Question Received from NRC Division of License Renewal:

Response to provide sufficient information to assess three new methods identified in NSAC-202L, Rev 4.

Descriptions for Three New Methods for Calculating Wear (NSAC-202L-R4)

Figure A-4
Histogram Showing Definite Wear

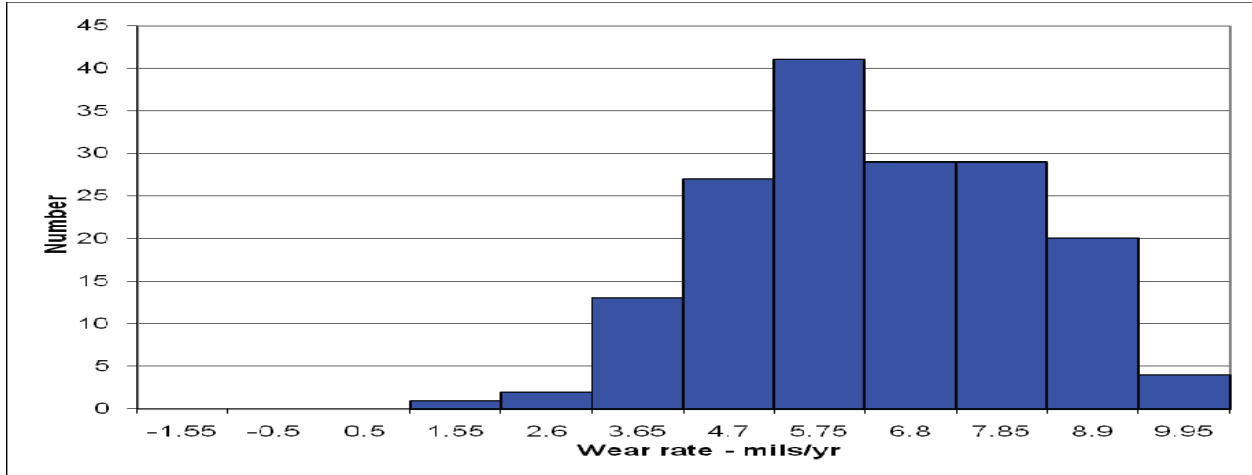
It is not clear which document(s) we would need to in order to have sufficient information to evaluate the three new methods for calculating component wear in order to determine the acceptability of NSAC-202L Rev 4.

- **Definite Wear** - Figure A-4 shows a case where there is definitely wear occurring as the median of the values is definitely positive and the shape of the histogram is skewed positively.
- **Definite No Wear** - Figure A-5 shows a case where there is definitely not wear occurring as the median of the values is near zero and the shape of the histogram is roughly symmetrical around zero wear.
- **Definite Wear - Bimodal Distribution** - Figure A-6 shows a case where there is a bimodal distribution. Typically one of the peaks will be near zero wear, and the other peak will be near the positive wear end. This situation indicates that wear is definitely occurring. Note that there is no counterpart of having a bimodal distribution with one peak at the negative end of the abscissa.
